ENGINE - FUEL AND CONTROL - REPLACEMENT OF FUEL TEMPERATURE THERMOCOUPLE WITH STUD AND NUT TERMINATIONS - CATEGORY CODE 4 - MOD.ENG-73-0075

- (1) Condition
Fuel Temperature Thermocouple fault messages occur on A5 and D5 Engines. Vibration at the harness connector is the most probable root cause.
- (2) Background
To improve the harness connection durability for the vibration.
- (3) Objective
To replace the Fuel Temperature Thermocouple with the stud and nut terminations and the EEC Fan Harness.
- (4) Substantiation
2 CSU engines (150 HRS) by A5 engines and vendor rig testing for the new thermocouple have been successfully completed.
- (5) Effects of Bulletin on Workshop Procedures:

To replace the Fuel Temperature Thermocouple with the stud and nut terminations and EEC Fan Harness Assembly.

Part schematic view of harness loom C showing clipping points affected - Before and after alteration
Fig.2

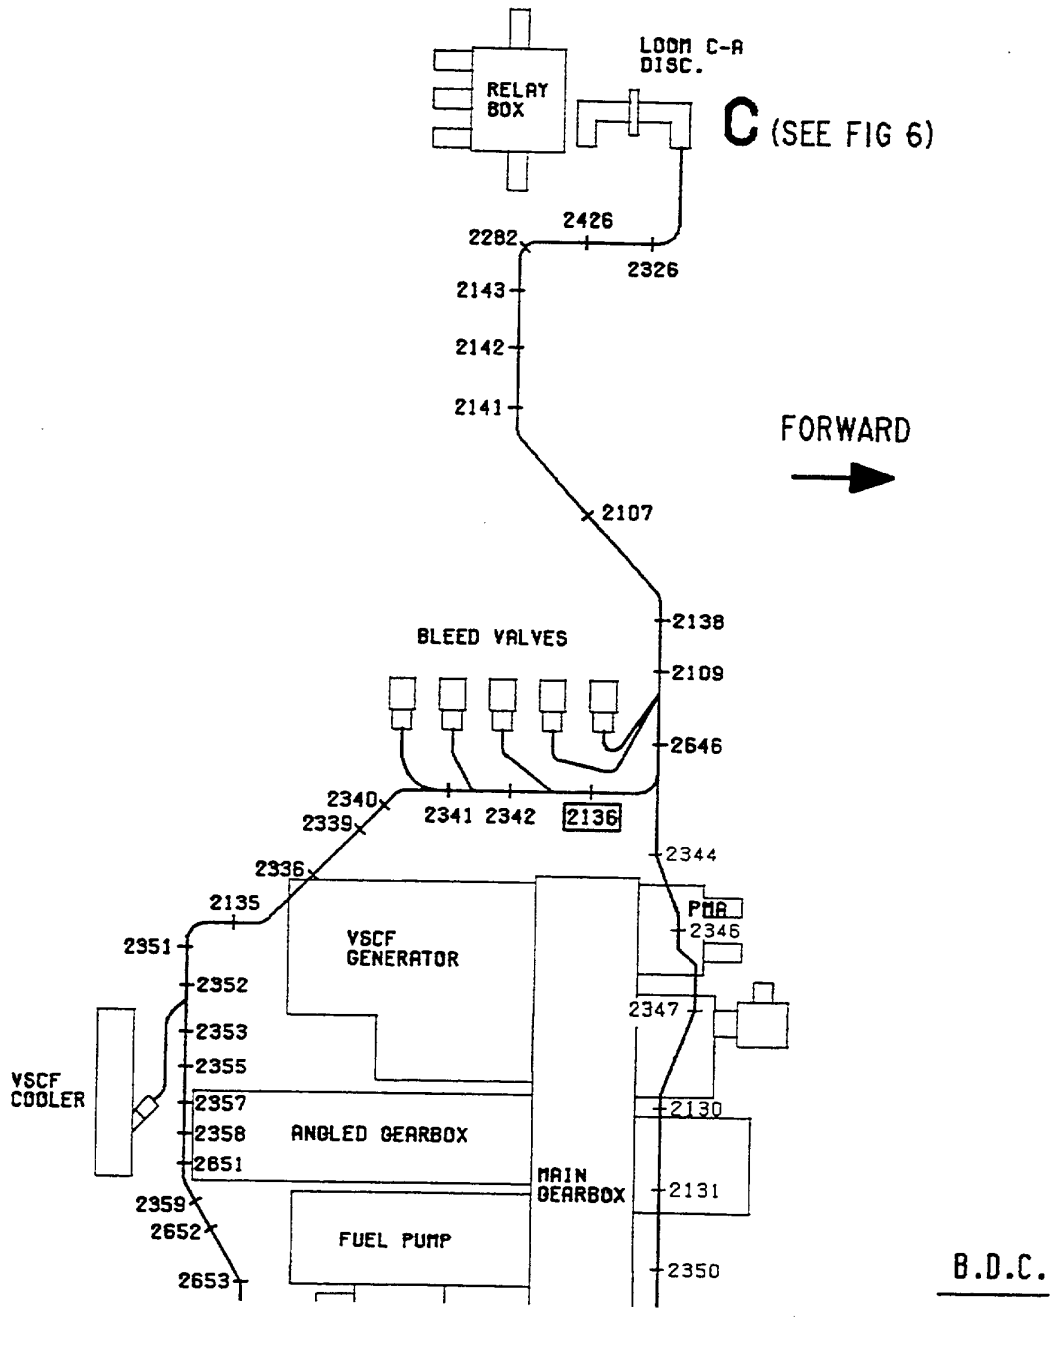
Procedure	Supplementary Information
(a) Cut off the Fuel Temperature Sensor connector P1-8050 from the EEC Fan Harness	Refer to Figures 2 and 4. Use standard workshop equipment

(d) Locate and disassemble the F.C.O.C. Temperature Thermocouple disconnects at position 'B' and 'C'	Refer to Figures 2, 3, 5 and 6. Use standard workshop equipment

(f) Cut off the two contact pins from each disconnect 'B' and 'C'	Refer to Figures 2, 3, 5 and 6. Use standard workshop equipment
(g) Protect the cut end	Refer to Figures 5 and 6. Use U322742 scotch boy tape

- (11) Disassemble clipping points CP2408 and CP2409 sufficiently to install the Harco Harness. Refer to Figures 2 and 10.
- (12) TORQUE the bolts at clipping points CP2408 and CP2409 to between 36 and 45 lbfin (4 and 5 Nm). Refer to 1.L.(2), Chapter/Section 70-23-11 and Figures 2 and 10.

- (13) Disassemble the remaining 44 clipping points, CP2063 to CP2326 sufficiently to install the Harco Harness. Refer to Figures 2, 3, 6, 12 to 33.
- (14) Install the Harco Harness through the 44 clipping points to follow the run of the EEC Fan Harness Loom C. Refer to Figures 2, 3, 6, 12 to 33.

Enlarged view at A (see Figure 2) showing rework of harness loom C at F.C.O.C. - Shown
thus for convenience

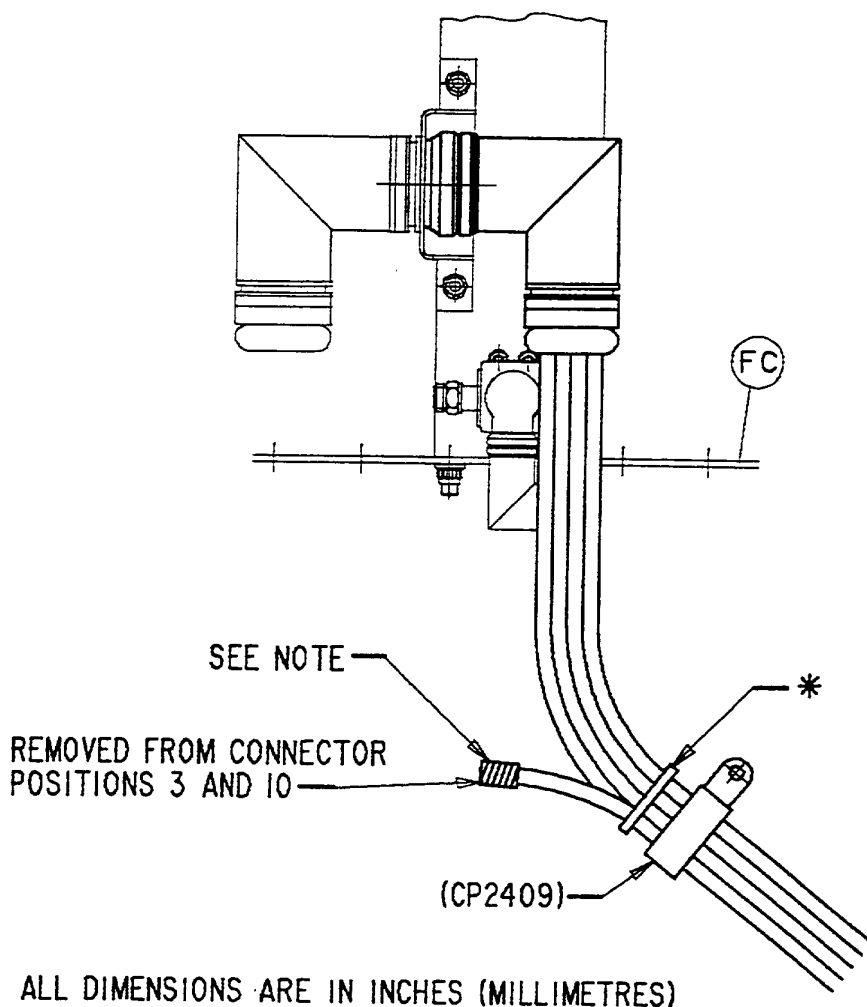
(b) Protect the cut end	Refer to Figure 4. Use U322742 scotch boy tape
(c) Tie back the cut end onto the existing EEC Fan Harness	Refer to Figure 4. Use T085 lacing (white), as necessary

- (b) Clean the backplate surrounding bolt hole areas, the bolt underfaces and the ground lug faces.
 - (c) Wipe clean with a V02-099 lint free cloth.
 - (d) Install the harness ground lugs and 4W0169 retaining bolts (2 off). TORQUE the bolts to between 85 and 105 lbfin (9,6 and 11,9 Nm). Refer to 1.L.(2), Chapter/Section 70-23-11 and Figures 4 and 8.

- (3) Clean the Thermocouple Harness locating threads using V01-410 isopropyl alcohol and wipe clean with a V02-099 lint free cloth.
 - (4) contact the harness to the Thermocouple at four positions using the HDA 13955 nuts (2 off) and HDA13956 nuts (2 off). Refer to Figures 4 and 8.

- (7) Tie two datum positions on each of the Harco Harness, HAB22497 and HAB22498 using V02-184 zebra lacing tape 718G. Refer to Figures 4 and 7.
 - (8) Disassemble clipping points CP2413 for harness HAB22497 and CP2065 for harness HAB22498 sufficiently to install the Harco Harness through the relevant clipping point until the datum ties are in position. TORQUE the bolts to between 36 and 45 lbfin (4 and 5 Nm). Refer to 1.L.(2), Chapter/Section 70-23-11 and Figure 4 and 7.

- (9) Tie the Harco Harnesses to the EEC Fan Harness using lacing tie T085 between clipping points CP2065 and CP2413. Refer to Figure 4.
- (10) Tie the Harco Harnesses together using lacing tie T085. Refer to Figure 4.

NOTE : HARNESS LIMBS TO BE CUT 1.299 (33.0) MAX FROM
CLIPPING POINTS AND EXPOSED ENDS TO BE TAPED UP
WITH A MINIMUM 2 TURNS OF SCOTCH BOY TAPE : U322742

Enlarged view at B (see Figure 2) showing rework of harness loom C at C-B disconnect -
Shown thus for convenience
Fig.5

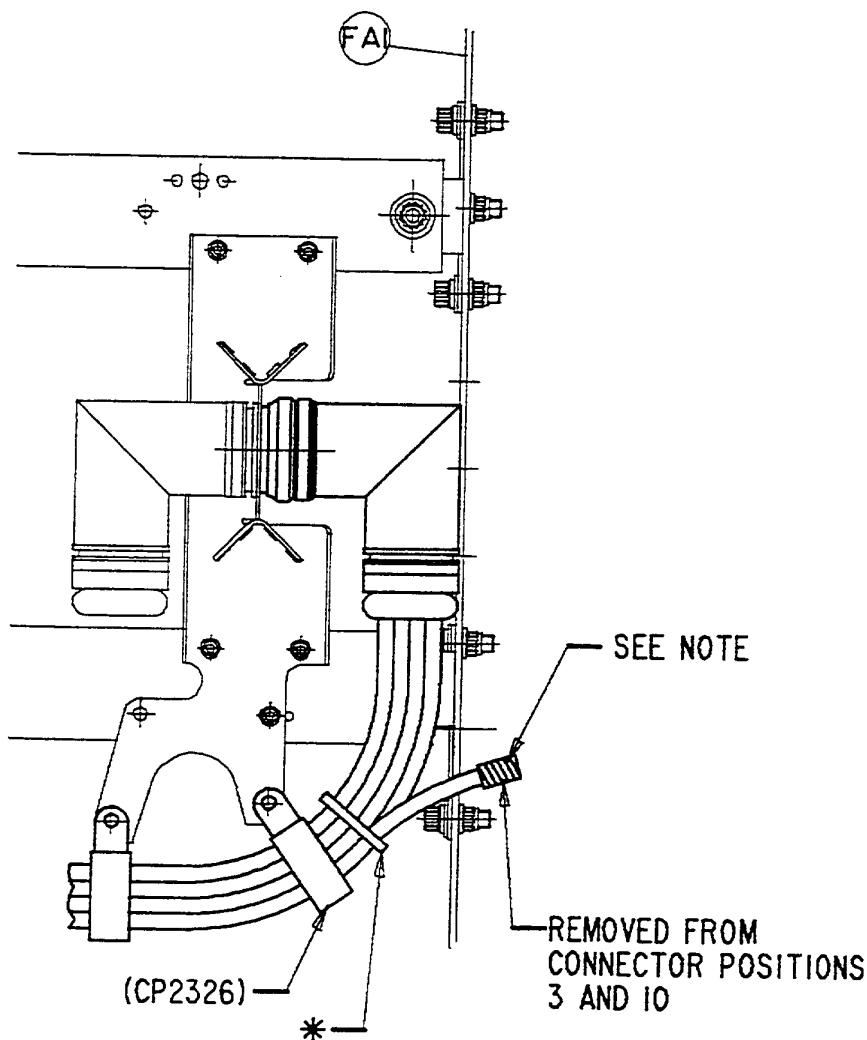
(h) Tie back the cut ends onto the existing EEC Fan Harness	Refer to Figures 5 and 6. Use T085 lacing (white), as necessary

(20) Connect the connector (P1-8005) at C-B disconnect after rework. Refer to Figures 2 and 5.

NOTE : HARNESS LIMB TO BE CUT 1.299 (33,0) MAX FROM CLIPPING POINTS AND EXPOSED ENDS TO BE TAPED UP WITH A MINIMUM 2 TURNS OF SCOTCH BOY TAPE : U322742

Enlarged view at C (see Figure 3) showing rework of harness loom C at C-A disconnect
Fig.6

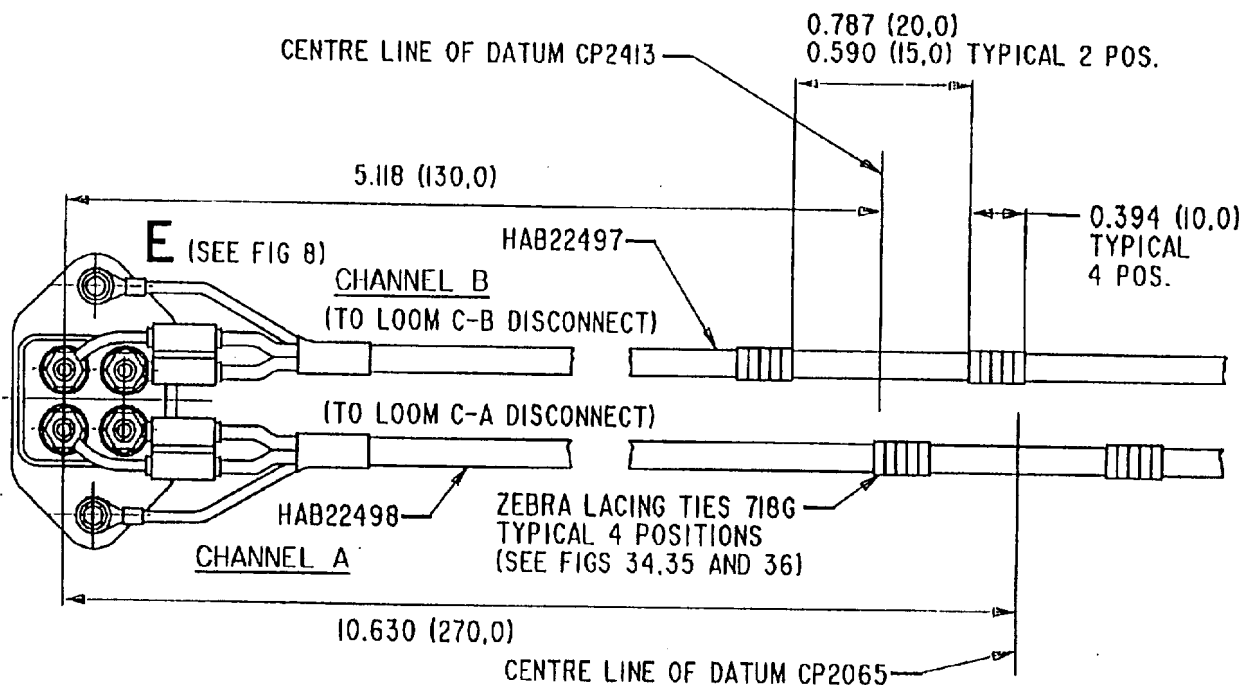
- (21) Connect the connector (p1-8002) at C-A disconnect after rework. Refer to Figures 3 and 6.

NOTE : HARNESS LIMB TO BE CUT 1.299 (33,0) MAX FROM
CLIPPING POINTS AND EXPOSED ENDS TO BE TAPED UP
WITH A MINIMUM 2 TURNS OF SCOTCH BOY TAPE : U322742

View on arrow D (see Figure 4) showing thermocouple harness datum positions - Shown thus for convenience

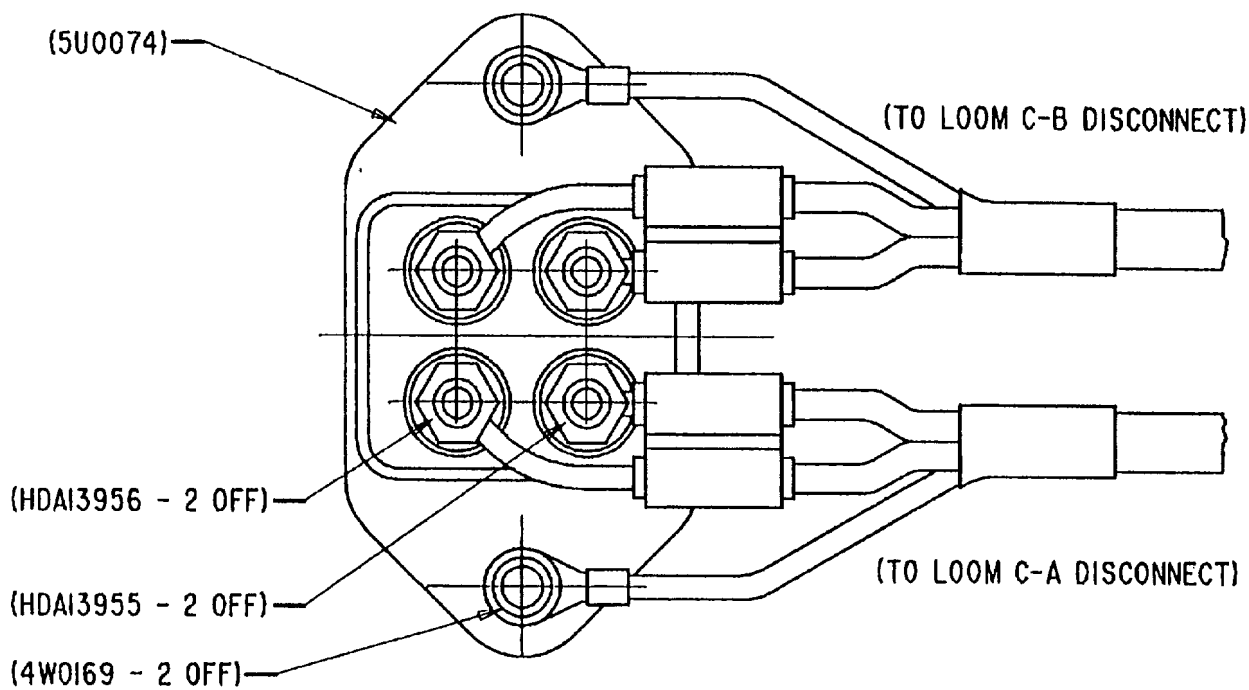
- CAUTION:** Do not exceed the recommended torque values. Over torquing may result in fracture of the temperature sensor studs.
- (5) TORQUE the HDA13955 nuts (2 off) to between 15 and 18 lbfin (1,69 and 2,03 Nm). Refer to 1.L.(2), Chapter/Section 70-23-11. Refer to Figures 7, 8 and 38.

- (6) TORQUE the HDA13956 nuts (2 off) to between 18 and 22 lbfin (2,03 and 2,48 Nm). Refer to 1.L.(2), Chapter/Section 70-23-11. Refer to Figures 7, 8 and 38.

Typical view showing Harco lead termination details at C-A disconnect (HAB22498) and C-B disconnect (HAB22497) - Shown thus for convenience
Fig.9

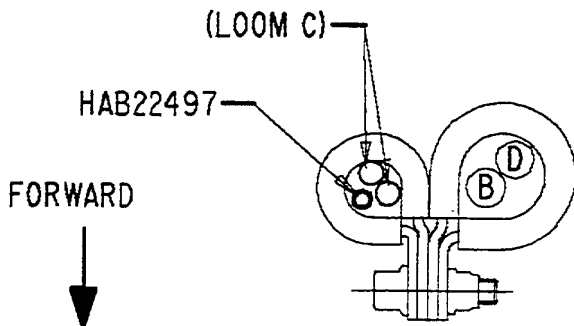
- (19) Install the new contact pins, to the new Harco EEC Fan Harness, HAB22497 and HAB22498, Refer to Figures 2, 3, 7 8 and 9.

CP2135 and CP2351 (see Figure 3 for position)
Fig.25

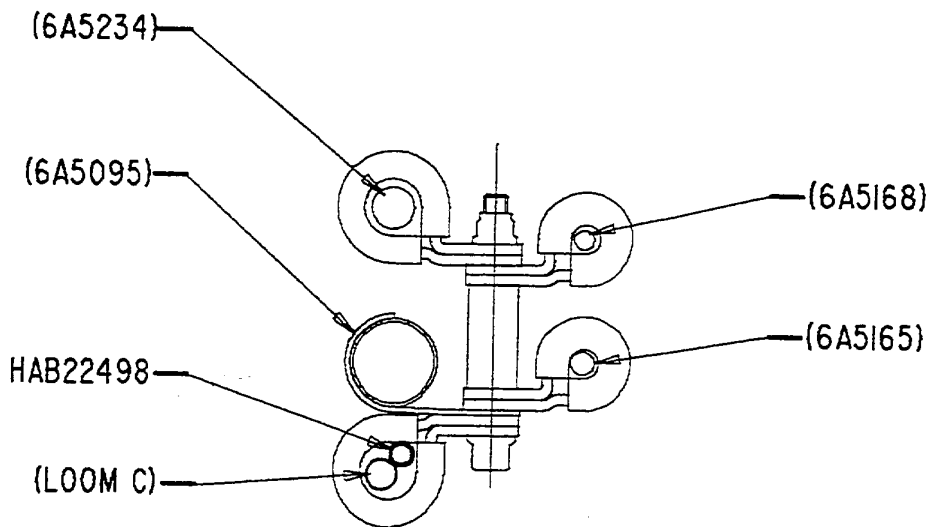
- (15) At clipping point CP2351 clean the mating faces of the existing parts. Refer to Figures 3 and 25.
 - (a) Use a clean lint free cloth made moist with V01-410 isopropyl alcohol.

- (b) Wipe clean with a V02-099 lint free cloth.
- (16) Assemble clipping point CP2351 using existing parts. TORQUE the bolt to between 36 and 45 lbfin (4 and 5 Nm). Refer to 1.L.(2) Chapter/Section 70-23-11 and Figures 3 and 25.

Removal/Installation of the Fuel Temperature Thermocouple
Fig.37

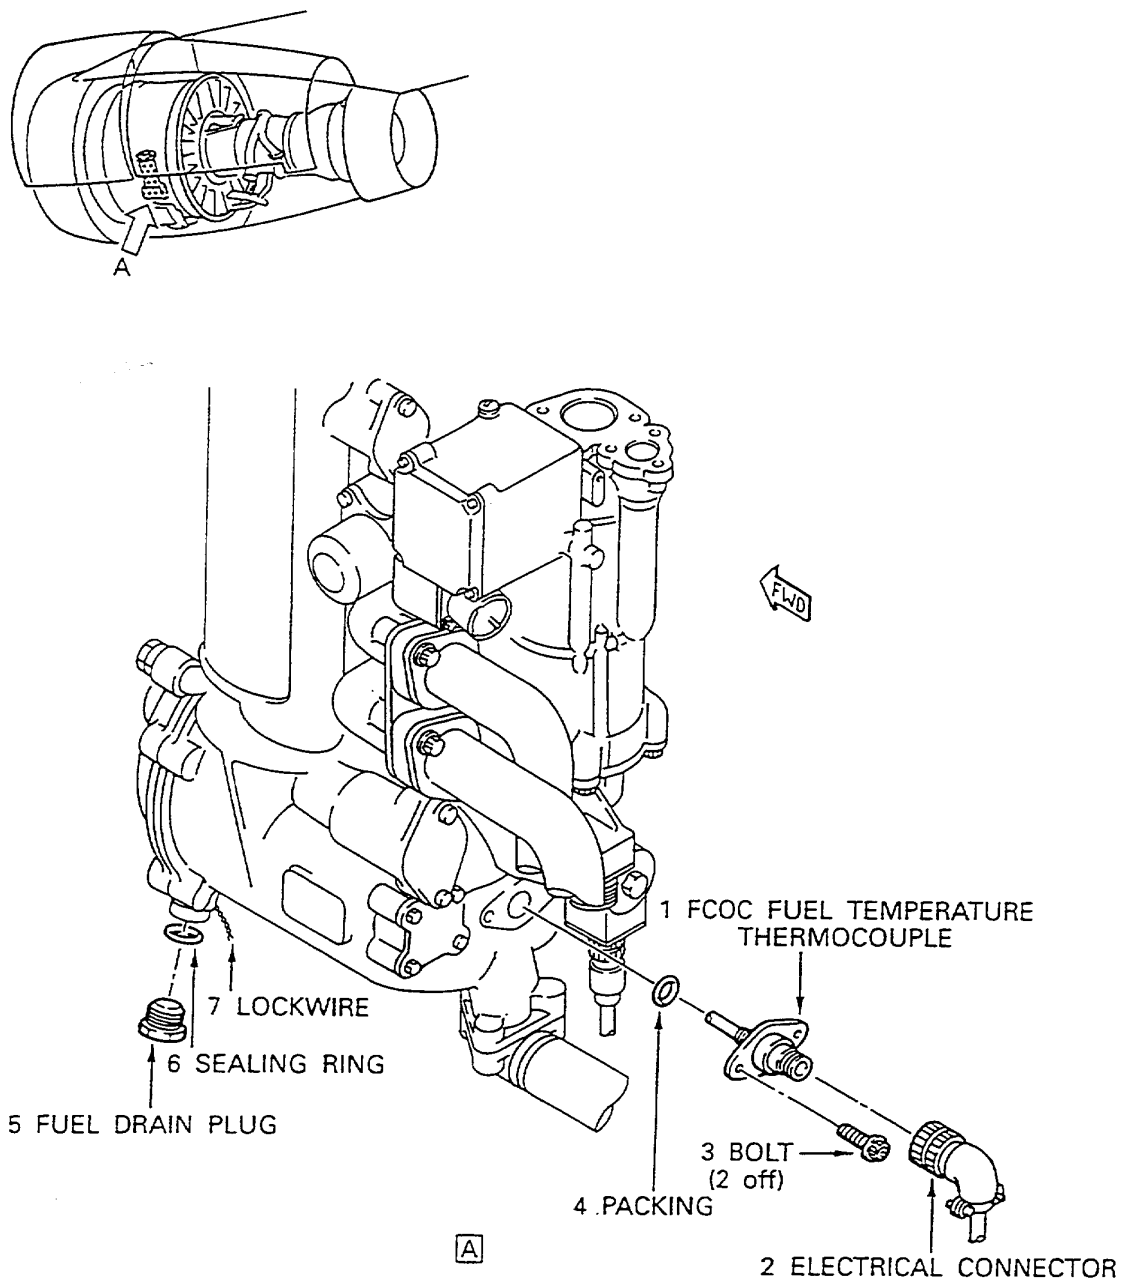
- (5) Remove the Fuel Temperature Thermocouple (73-35-15, 01-100 P/N 73984200) with the instructions given in the Reference 1.L.(2) Chapter/Section 73-32-02 Page Block 401. Refer to Figure 37. Right Hand Engines Only - During draining of the F.C.O.C. it is recommended that a funnel fitted with a hose should be used with the container to assist in this task.

- (1) Install the new Fuel Temperature Thermocouple (73-35-15, 01-100 P/N HAD22308) with the instructions given in the Reference 1.L.(2), Chapter/Section 72-32-02 Page Block 401. Refer to Figures 37 and 38.

Improvement of the Fuel Temperature Thermocouple
Fig.38

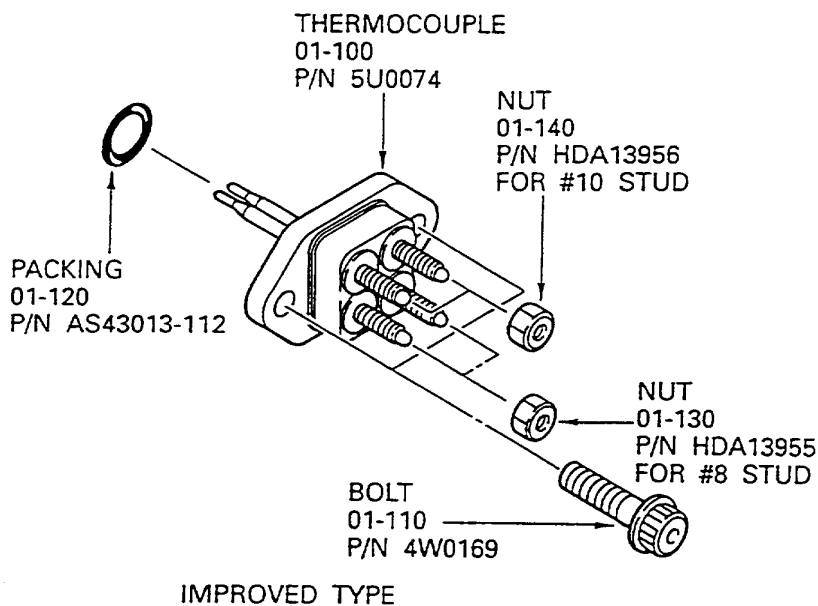
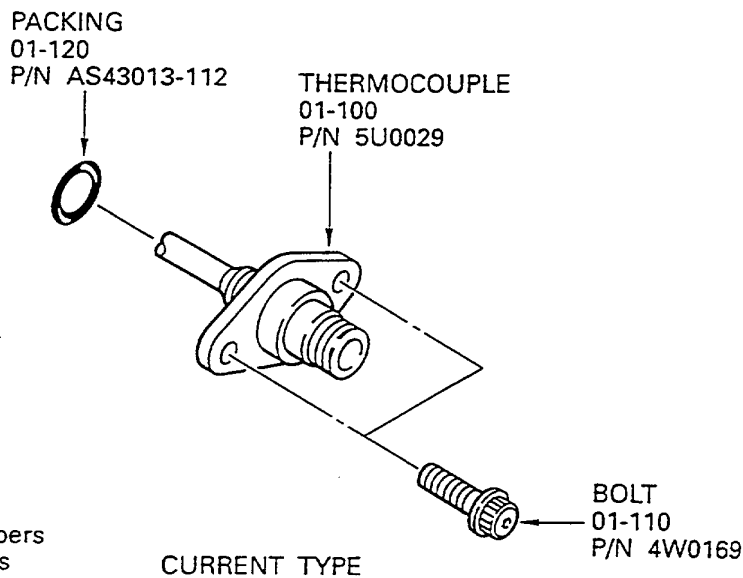
- (2) Remove the 4W0169 Thermocouple retaining bolts (2 off), one at a time. Refer to Figure 38.
 - (a) Use a clean lint free cloth made moist with V01-410 isopropyl alcohol.
